SERVICE BULLETIN

APPLICABILITY: 2014MY XV Crosstrek Hybrid Models (HEV)
SUBJECT: Relay Freezing Causing DTCs P1C30 and U0110

NUMBER: 07-98-15
DATE: 01/22/16

1. Drive Motor Control Module (DMCM)
2. DMCM Mounting Bracket
3. Relay Holder
4. DMCM Power Relay
5. Cooling Fan / Drive Motor Inverter Power Supply Relay

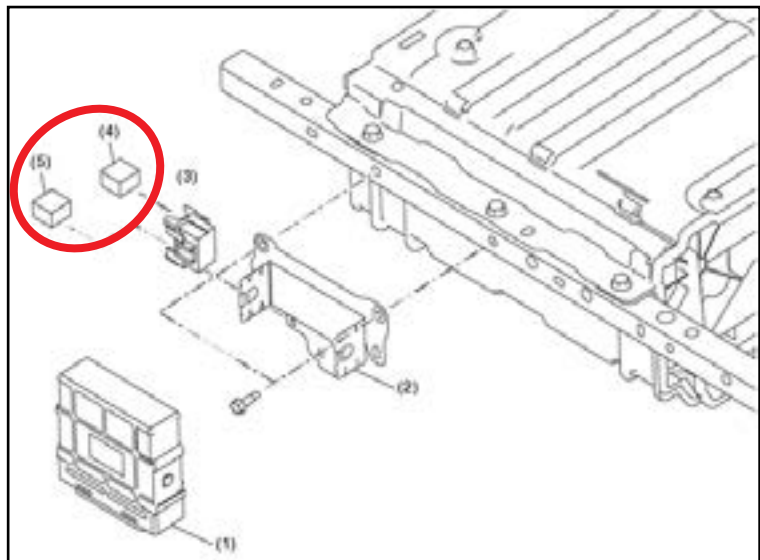
This bulletin announces a change to the power supply relay used for the Drive Motor Control Module (DMCM) and the cooling fan / drive motor inverter. In specific cold climate (below freezing) conditions, if there is a small amount of condensation inside the relay, it can in rare cases freeze and cause the relay to remain open which in some cases, sets DTCs P1C30 and / or U0110.

PRODUCTION CHANGE INFORMATION:

The new relays have been used in production since September, 2014.

The part number for the new relay is **25230AA190**.

NOTE: The new p.n. 25230AA190 replaces the original p.n. 85201AG041 **for these 2 relay applications only**. The original p.n. 85201AG041 relay is used elsewhere in the vehicle and remains the correct part to use for those other applications as specified in the Parts Catalog.

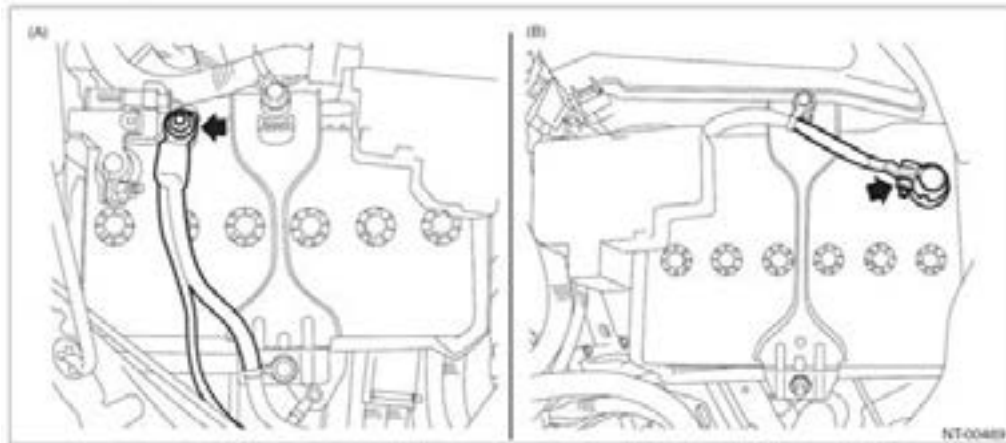
- The relays are located on the left (driver) side of the DMCM mounting bracket (2). Remove the sub-trunk (tray) assembly by removing the orange retaining clip and releasing the claws on either end as shown in the illustration below. Remove the 2- 10mm hex bolts securing the DMCM mounting bracket to gain access to the relays. After replacing the relays, when re-tightening the mounting bolts, torque to 4.8 ft. lbs.

12v Engine Restart Battery (A)

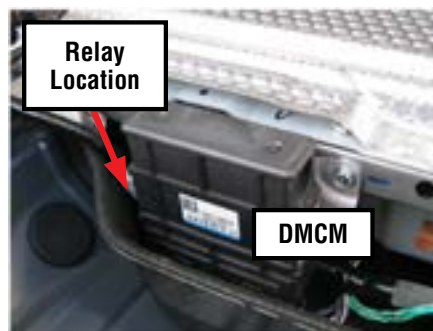
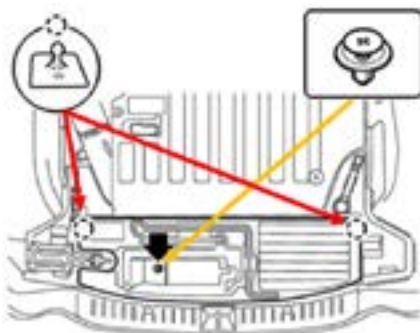
- If DTC P1C30 and / or U0110 are found stored in memory and the outside temperatures are (or were recently) below freezing, replace both of the power supply relays (4 and 5) as shown in the illustration above.
- Record the customer's radio station presets (and navigation favorites where applicable).
- When either of the power supply relays is replaced, both the auxiliary and the engine start batteries must be disconnected, **auxiliary battery first**. Remove the 12mm nut from the restart battery sensor stud and remove the cable along with the ground terminal from the Auxilliary battery.

IMPORTANT: DO NOT remove the sensor assembly from the restart battery terminal.
